Product Change Notification

1. ECN #: 293105

- SEAF - .050 PITCH SOCKET ARRAY ASSEMBLY

Previous Revision Product

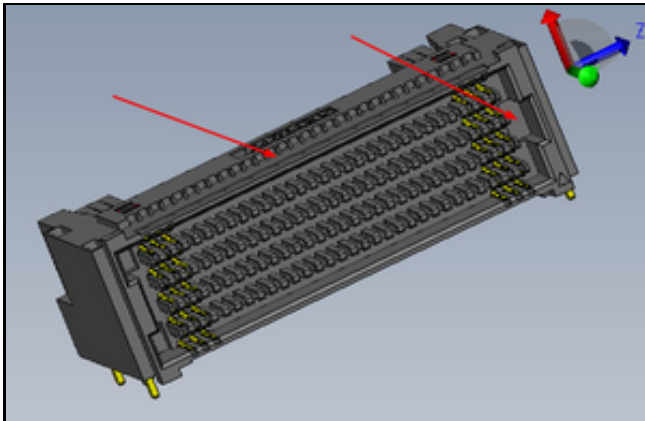
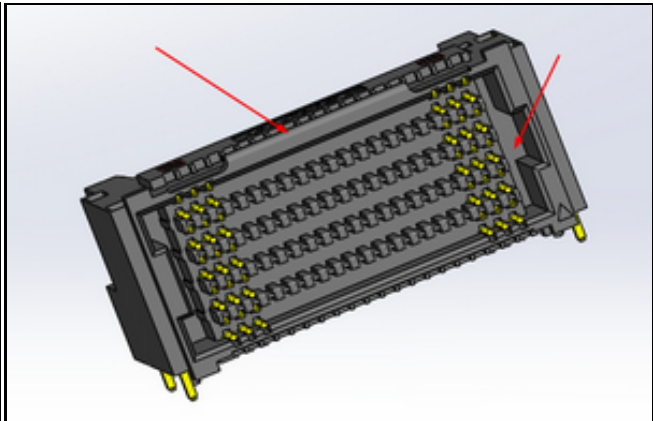
Form change only; a top lip was added and the shroud depth was increased. This will be a rolling change and new revision material will be used once current revision material is depleted. This change has no effect on mating with existing SEAM connectors.

On the new product, there is a raised section in the center of the top of the mating face. On the old revision, this area was flat.

- Form - There is an elevated part on the mating face that is coplanar with the top standoffs.
